ENGINEERING AMENDMENT:

TO AN APPLICATION FOR
A NEW NON-COMMERCIAL
EDUCATIONAL FM STATION
CHANNEL 215 B, 90.9 MHZ

SHAFTER, CALIFORNIA

SKYRIDE UNLIMITED, INC.

EXHIBIT VB-8
VERTICAL PLAN SKETCH
NEW NCE FM SHAFTER, CA 10/91

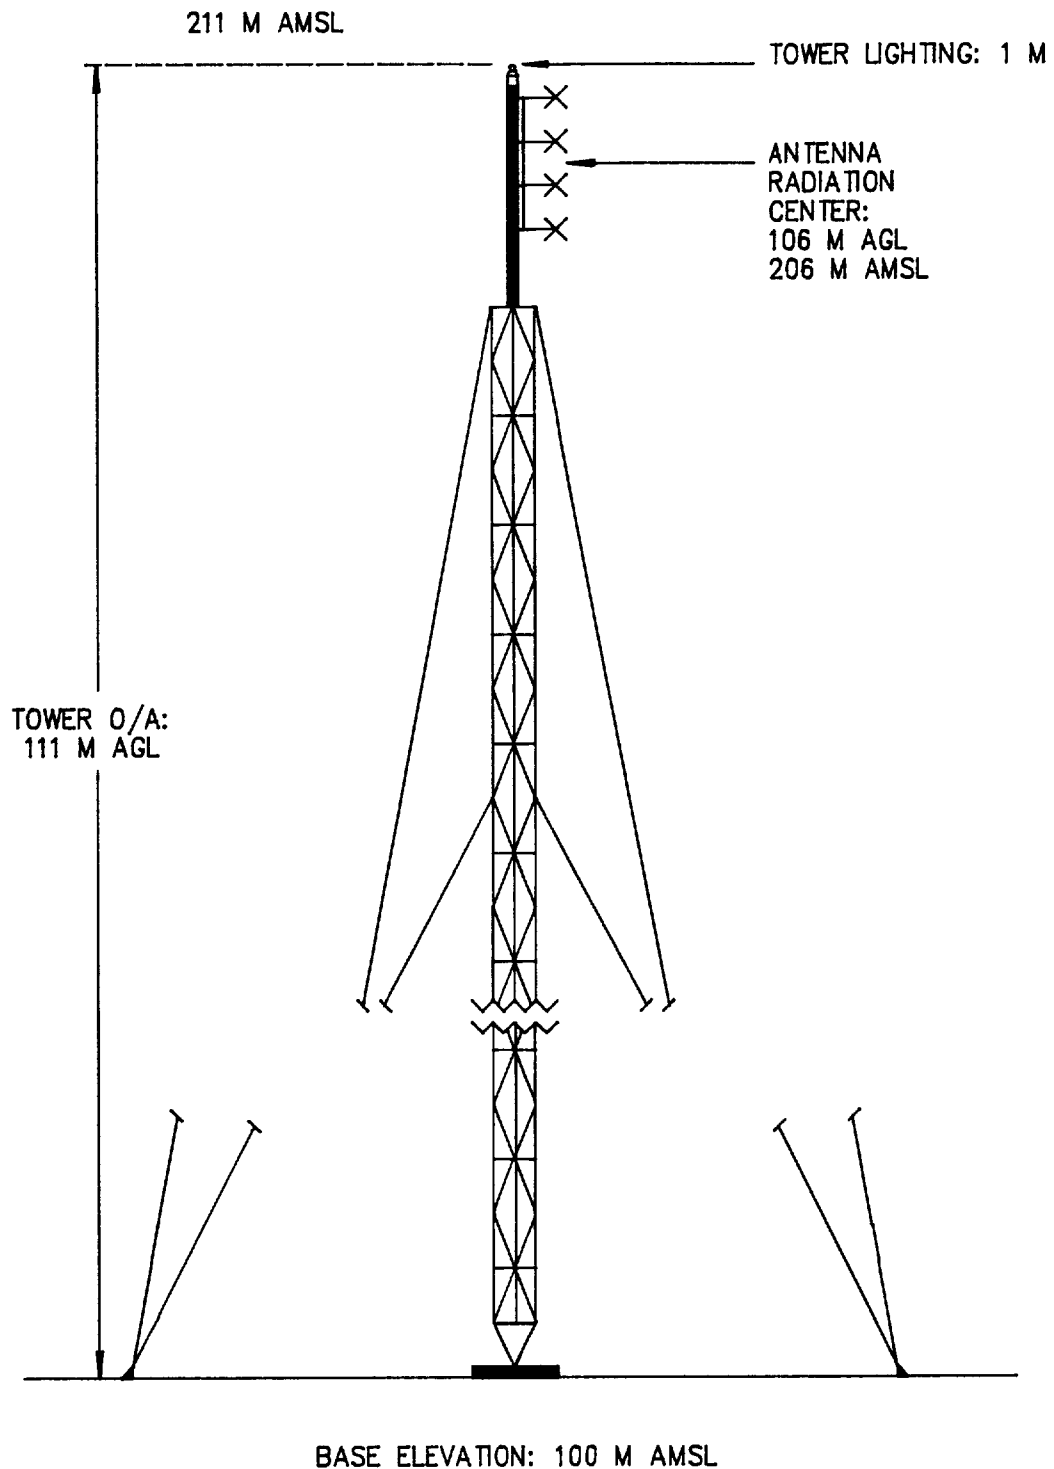
This Engineering Amendment supplies additional and corrected data to an application, BPED-901004MM, for a new non-commercial educational FM station at Shafter, California, previously submitted by Skyride Unlimited, Inc. In response to letter #8920-AJA from the F.C.C. dated October 22, 1991, the vertical plan sketch and form 340 V-B have been revised to correct metric conversion round-off error. The amended pages specify an overall tower height that is in agreement with the tower file database. This error results from the fact that the Commission requires data to be submitted in whole meters while the F.A.A. requires that data be submitted in feet.
